Docket No. 50-213
B14779

Haddam Neck Plant

Proposed Revision to Technical Specifications

Pressure Temperature Limits - Retyped Pages

FIGURE 3.4-5
 HADDAM NECK REACTOR COOLANT SYSTEM COOLDOWN
 LIMITATIONS FOR 22 EFFECTIVE FULL POWER YEARS

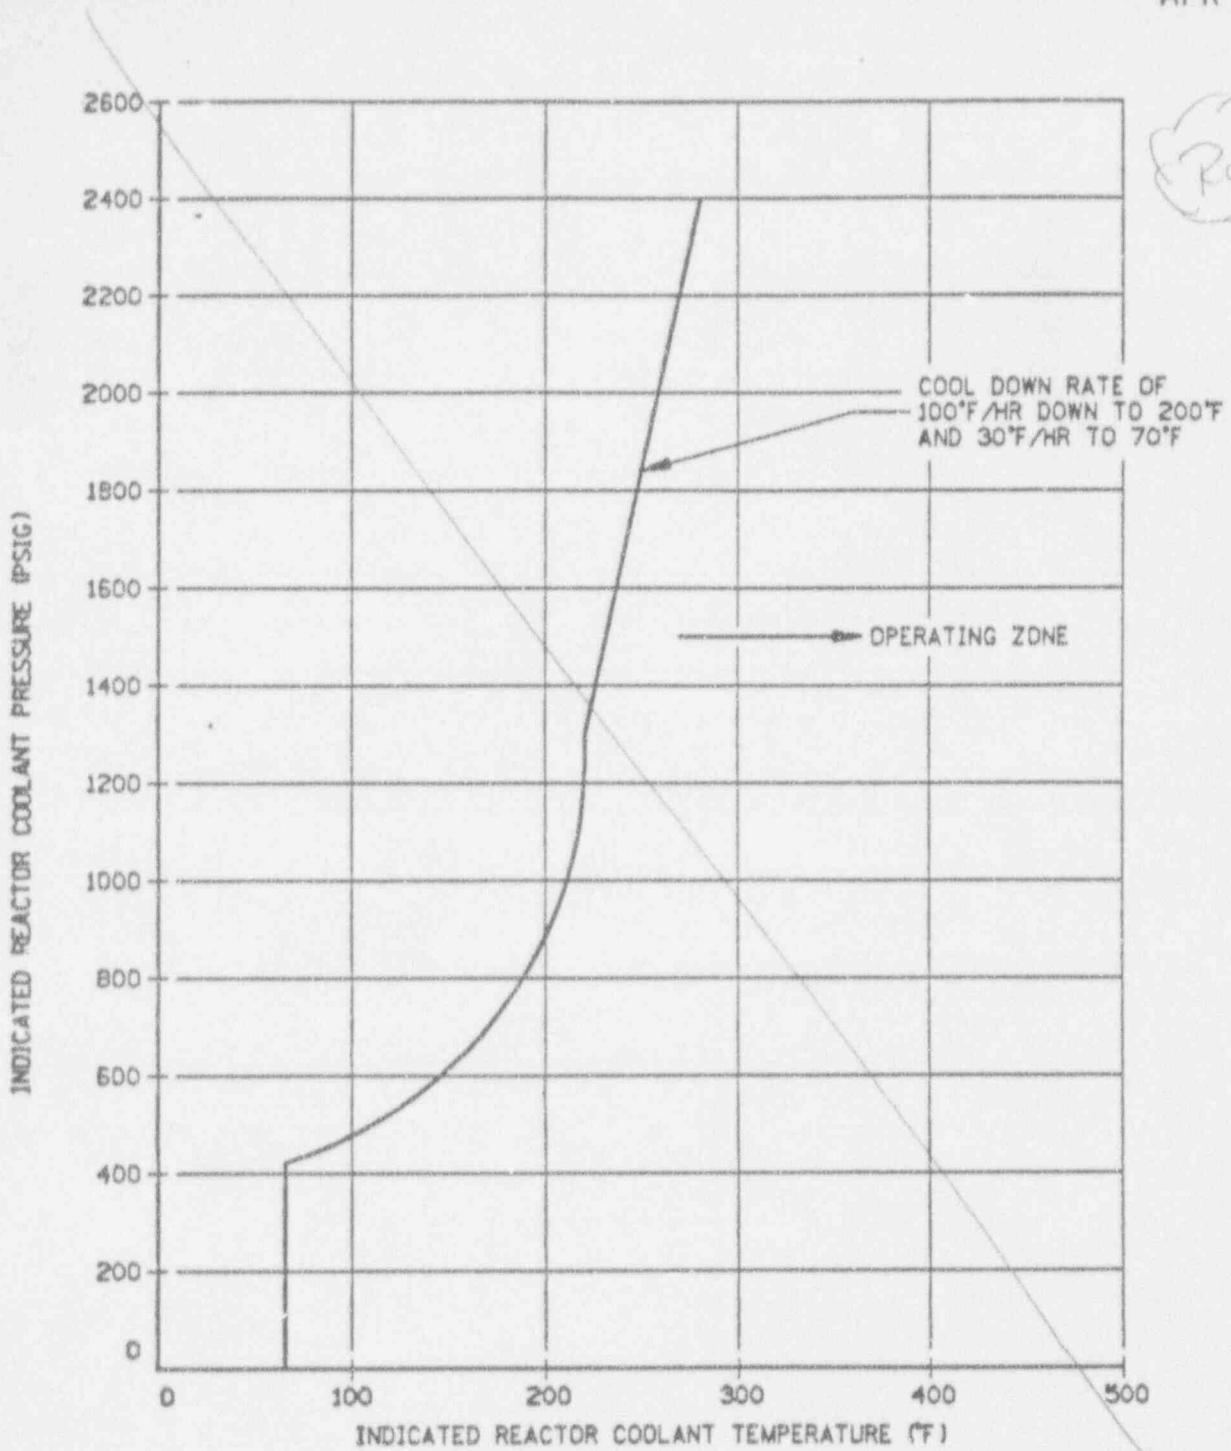
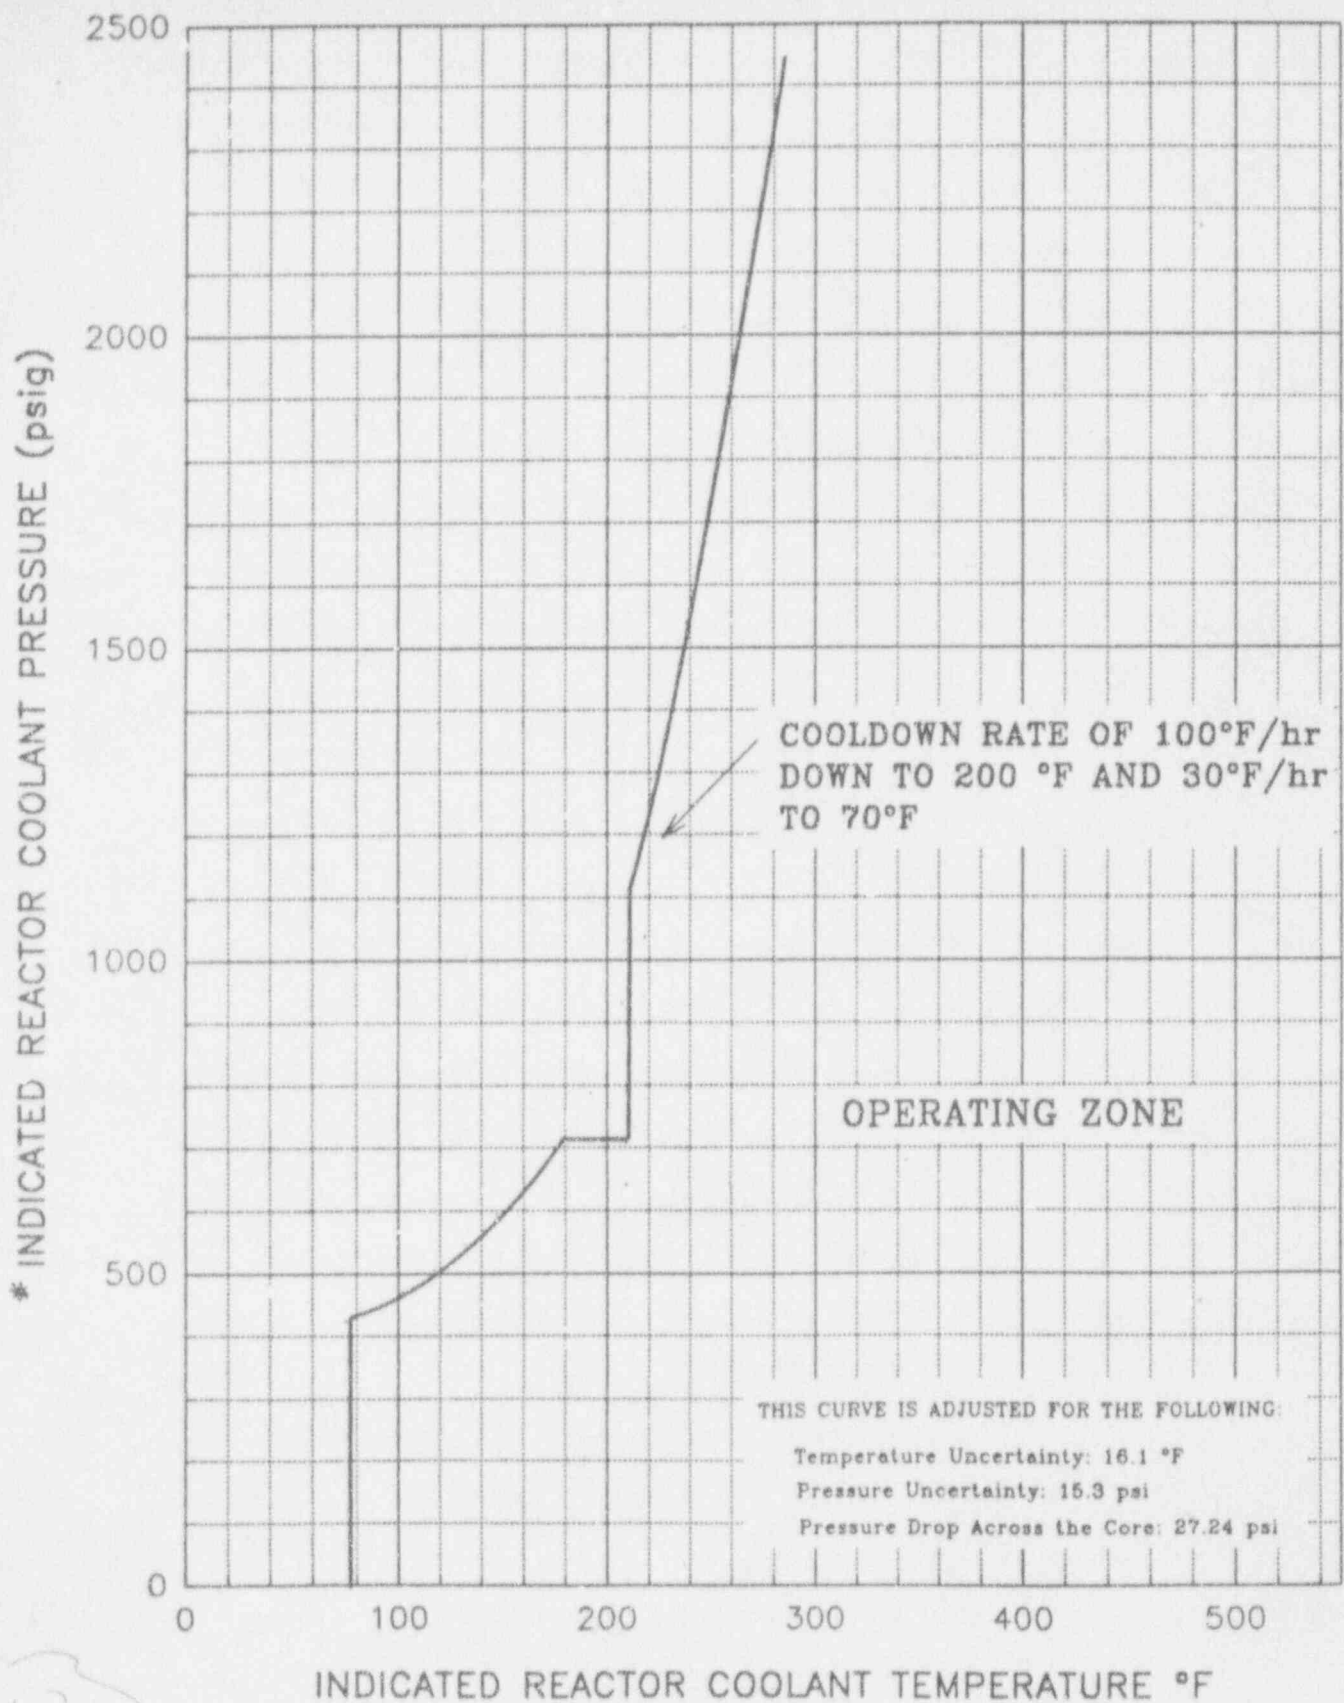
REPLACE

FIGURE 3.4-5
CONNECTICUT YANKEE REACTOR COOLANT SYSTEM COOLDOWN
LIMITATIONS FOR 22.0 EFFECTIVE FULL POWER YEARS
(T ERROR = 10°F, P ERROR = 60 PSIG)

*AS INDICATED BY THE NARROW RANGE PRESSURE TRANSMITTERS
